Subject: AP1000 Responses to Requests for Additional Information (SRP3)

AP1000 TECHNICAL REPORT REVIEW

RAI Response Number: RAI-SRP3.8.3-SEB1-04
Revision: 0

Figure RAI-SRP-3.8.3-SEB1-04-01
Typical detail at base of CA01 Module Wall with single layer of dowel bars

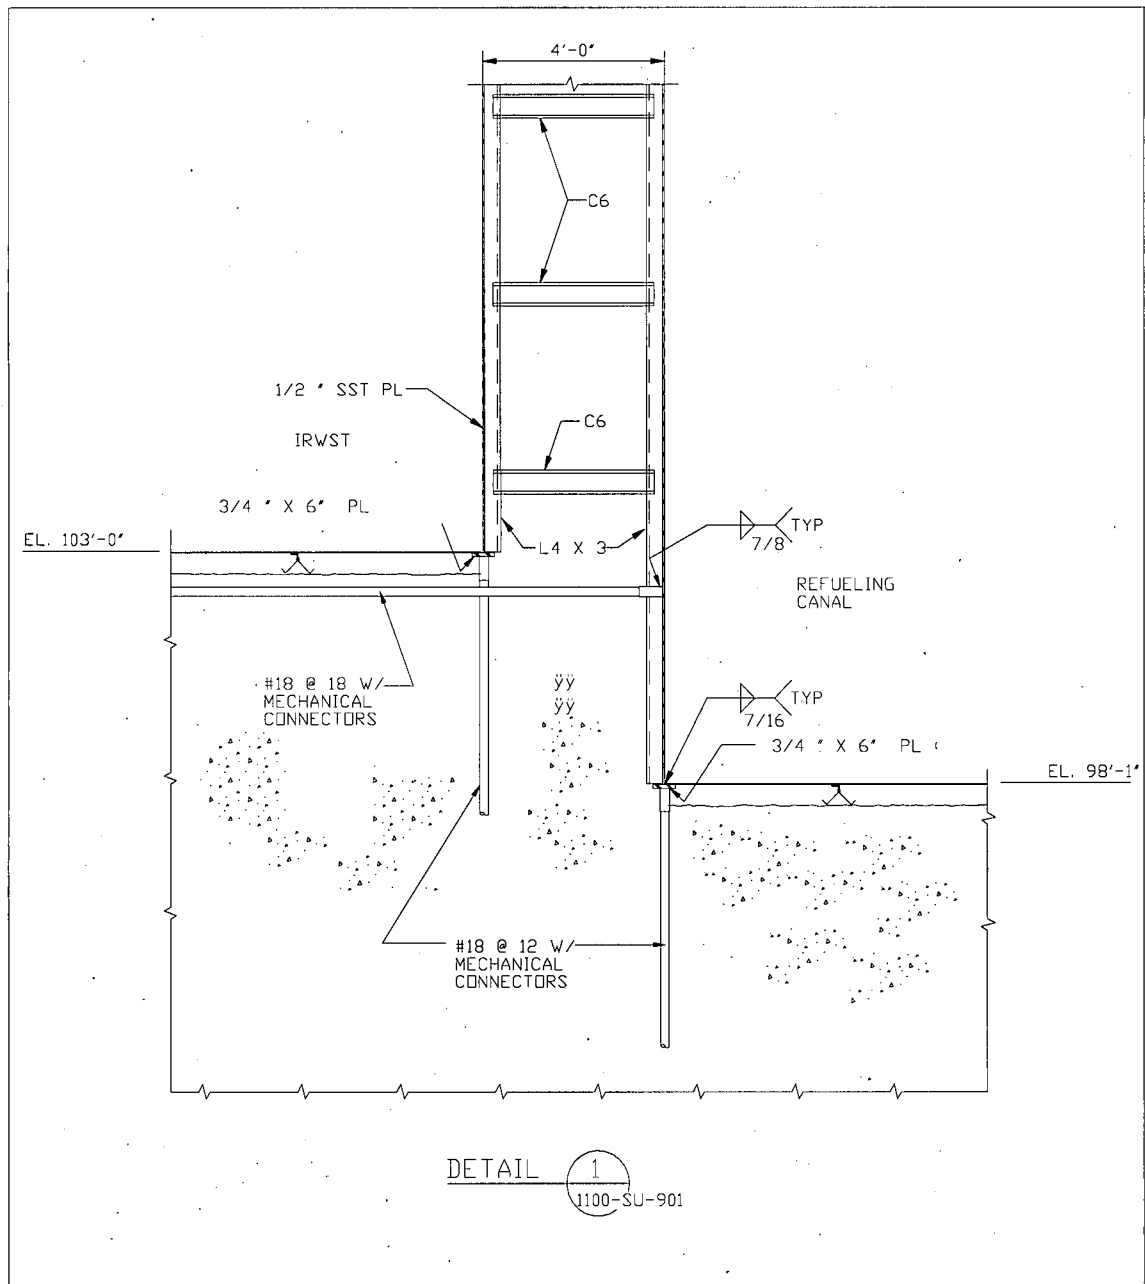
1. The left side of Figure 3.8.3-8, sheet 2, shows that the mechanical connectors that are welded to a $\frac{3}{4}$ inch plate at the base of the module is identified as "CONT" (presumably meaning continuous) on one side of the module and on the other side the term "CONT" is struck out. Explain which detail is correct and revise the figure accordingly. Were the design detail calculations completed for this connection? Explain how the large loads coming from the CIS wall modules can be properly transferred from the module wall plate at a localized point to the embedded connectors.

1. The plate at the base of the module does not need to be continuous. The revised typical detail is shown in Figure RAI-SRP-3.8.3-SEB1-04-01 and will be included in the DCD. An alternate version of this detail is used in cases where the trusses are extended into the basemat as shown in RAI-SRP-3.8.3-SEB1-04-02. The vertical dowel bars are placed in two layers. The base plate is stiffened to transfer the loads from the module wall plate to the embedded connectors. The design of the surface plate, base plate, and vertical stiffeners is checked by finite element analysis using the model shown in Figure

Delete "cont" from left side of DCD Rev 17 Figure 3.8.3-8, sheet 2, as shown corrected in Figure RAI-SRP3.8.3-SEB1-04-01.
